**KNOXVILLE HISTORIC ZONING COMMISSION
STAFF REPORT - CERTIFICATE OF APPROPRIATENESS APPLICATION**

PROPERTY ADDRESS: 221 Oklahoma Blvd 37917

FILE NO.: 1-A-19-HZ

MEETING DATE: 1/17/2019

221 E. Oklahoma Ave – Front elevation

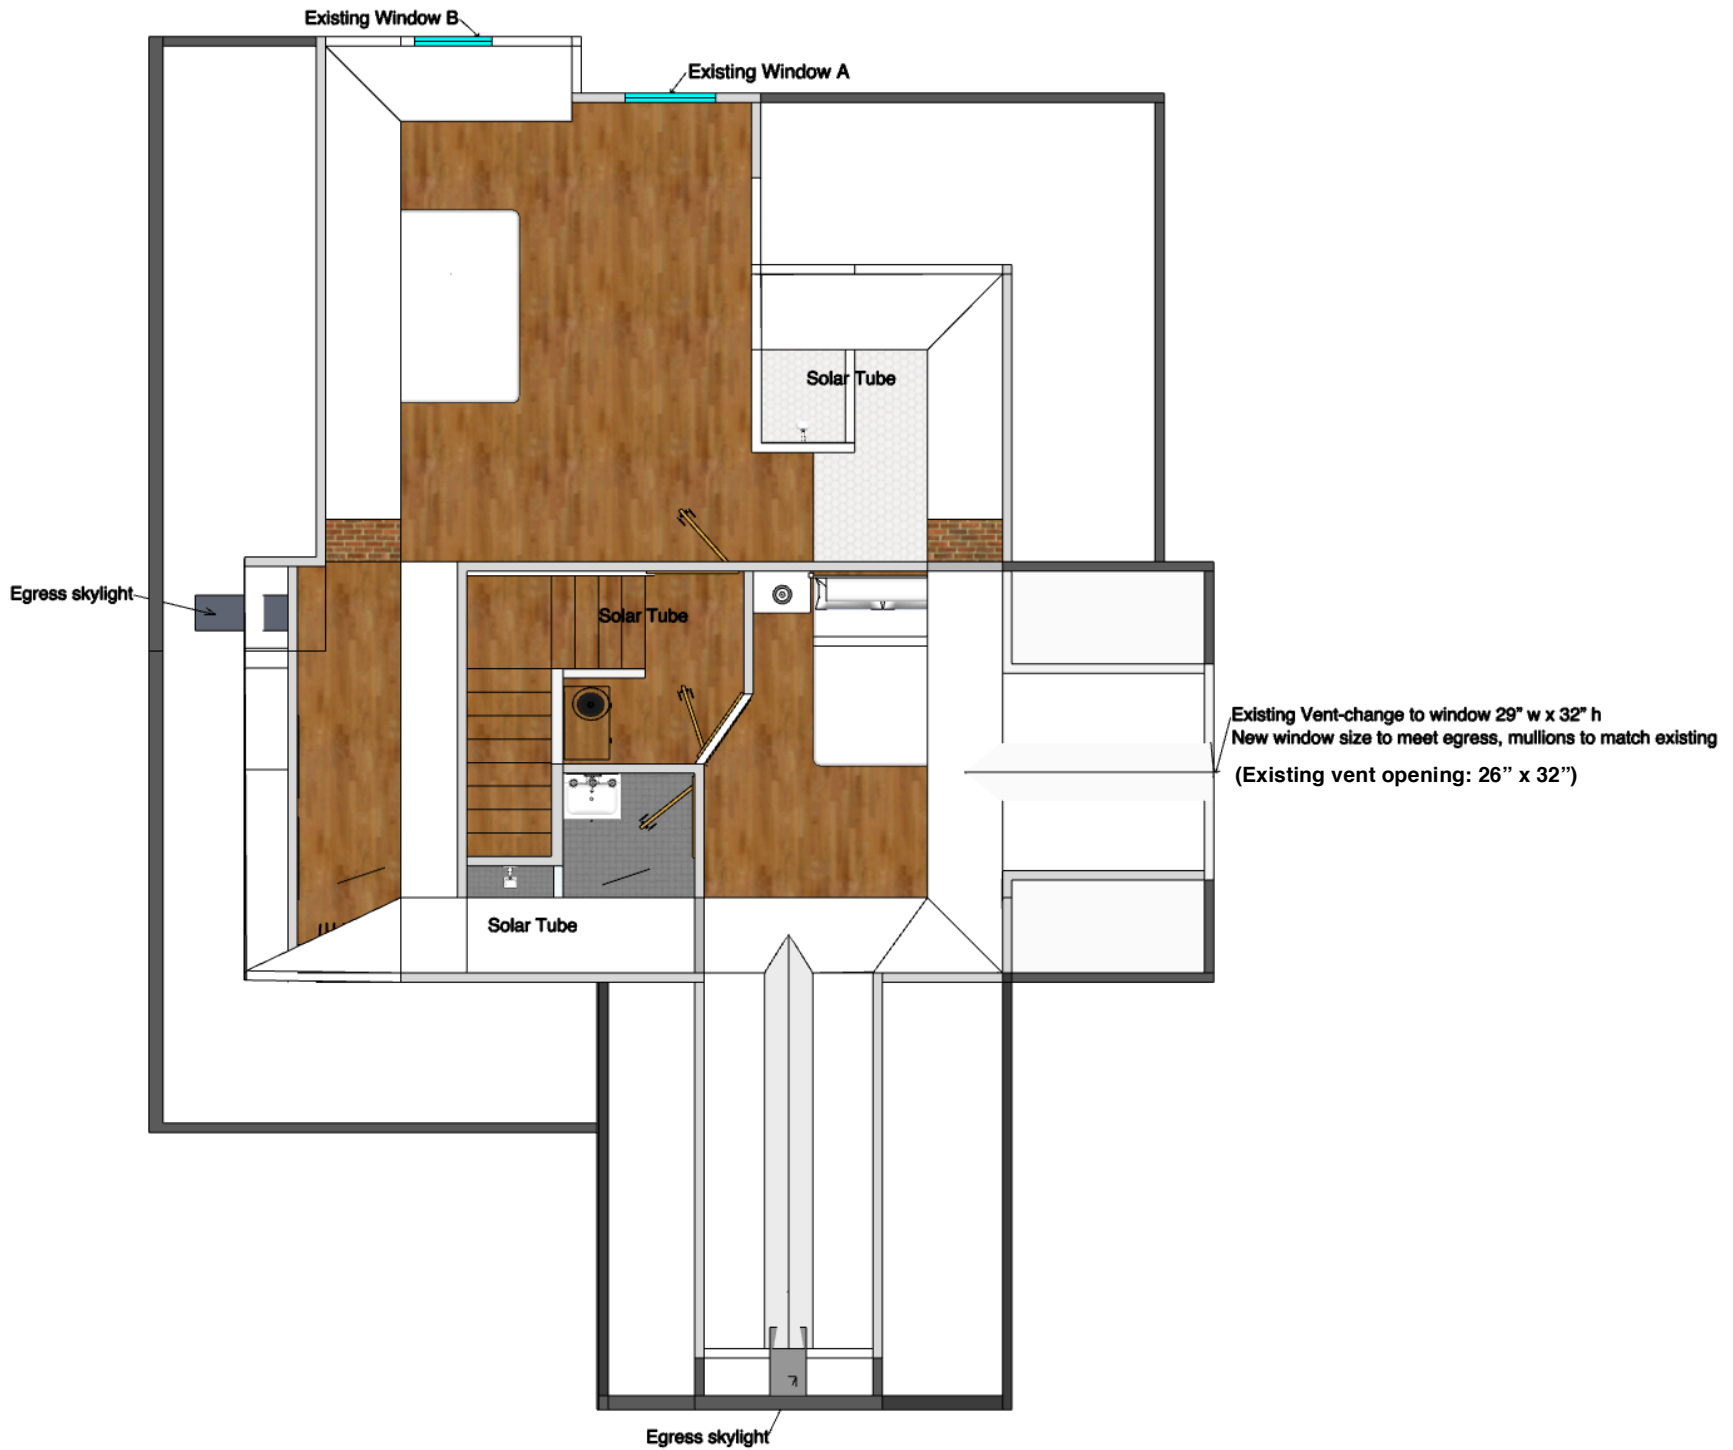
Egress through vent casement window

Propose to enlarge side gable window for egress. The horizontal dimension will only need to change 1.5" in each direction for total of 3".

Gable vent that was originally a window. See photo above from previous owner with original window (now missing) on right. New casement window will have the same mullions.

Proposed egress placement, behind the chimney, rear of east side

Egress through Skylight-

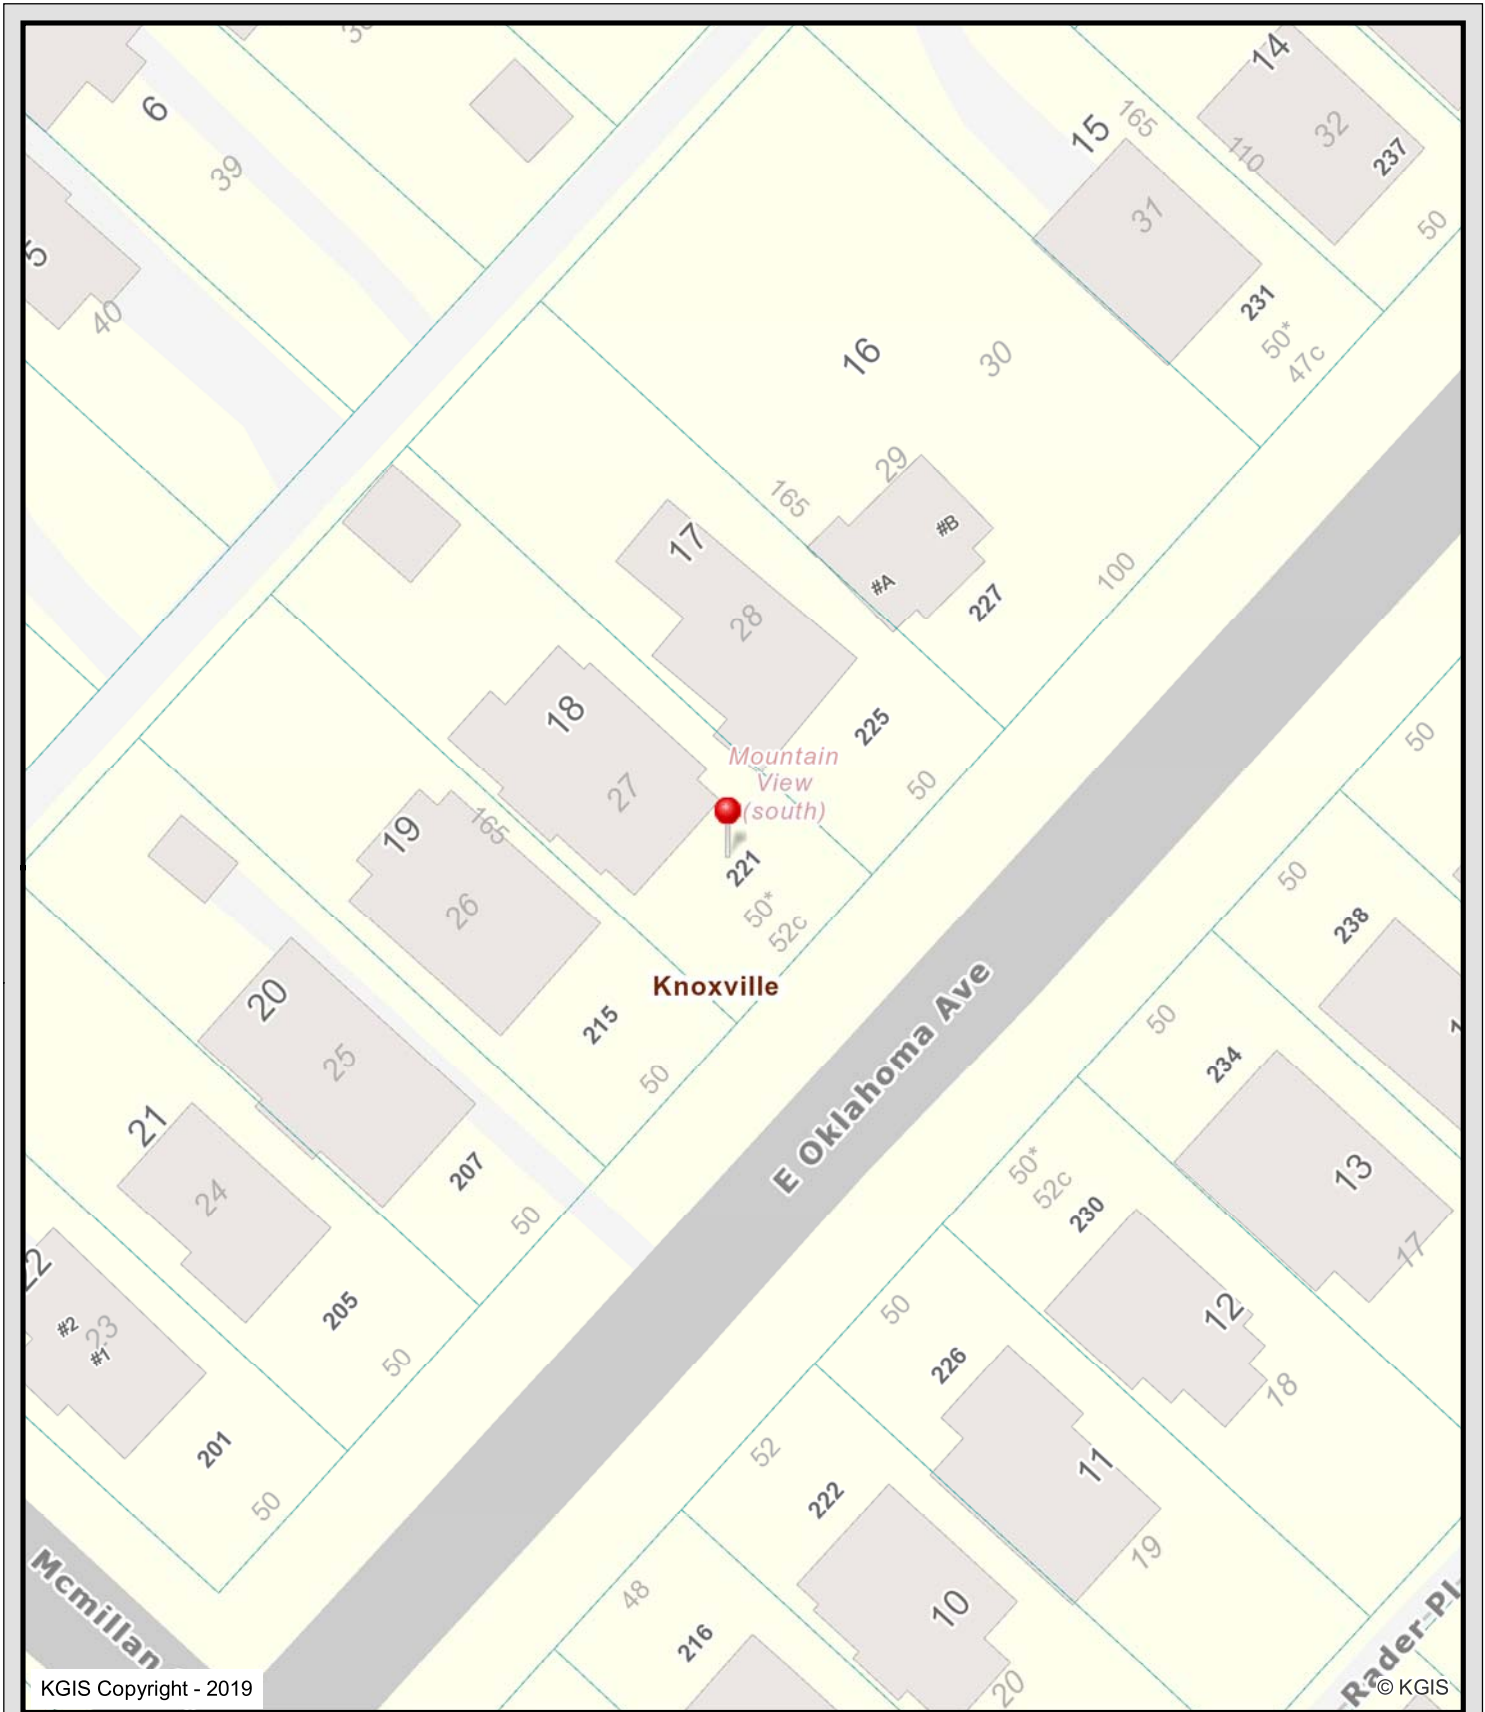
Discussion: Owner representative, Arin Streeter was present. Mr. Streeter noted that in discussion with the neighborhood representative, James Pierce, the most pressing issue with the Application is the visibility of the corner of the proposed skylight. Mr. Streeter stated he feels the small amount of the corner of the skylight, visible only from one particular angle, is minor given the increased usability of the home it would provide. He further stated that no original materials will be removed with the installation of the

skylight. Mr. Pierce was present and stated the neighborhood agreed with staff recommendation to approve the addition as it meets all requirements of the design guidelines. He noted the guidelines state that a skylight should not be visible from the street; however, deferred to the Commission to decide if it was acceptable. He further noted that he did not get any input from the neighborhood regarding the skylight. Ms. Graybeal noted that staff is recommending approval of the skylight as the visibility is minimal and has little effect on the integrity of the streetscape or the house. It was clarified that the rendering of the skylight is hand-drawn and approximate. Mr. Streeter noted the skylight will be colored to match the shingles and further noted that it will be the narrowest profile available. He also stated that a smaller skylight would not be effective and the one proposed is the smallest practical skylight for the room. Comm. Busby noted that the skylight corner was not continuously nor prominently visible. It was further stated that it is on the side of the roof, not the front.

Action: Comm. McAdams moved that the submitted application be approved based on the evidence submitted and the information provided in the staff report. The Motion was seconded by Comm. Martin. Comm. Woodle restated that the rendering of the skylight was only an estimation of visibility not a photo of the actual one proposed. The Motion carried with Comms. Bolen, Whetsel and Woodle voting no.
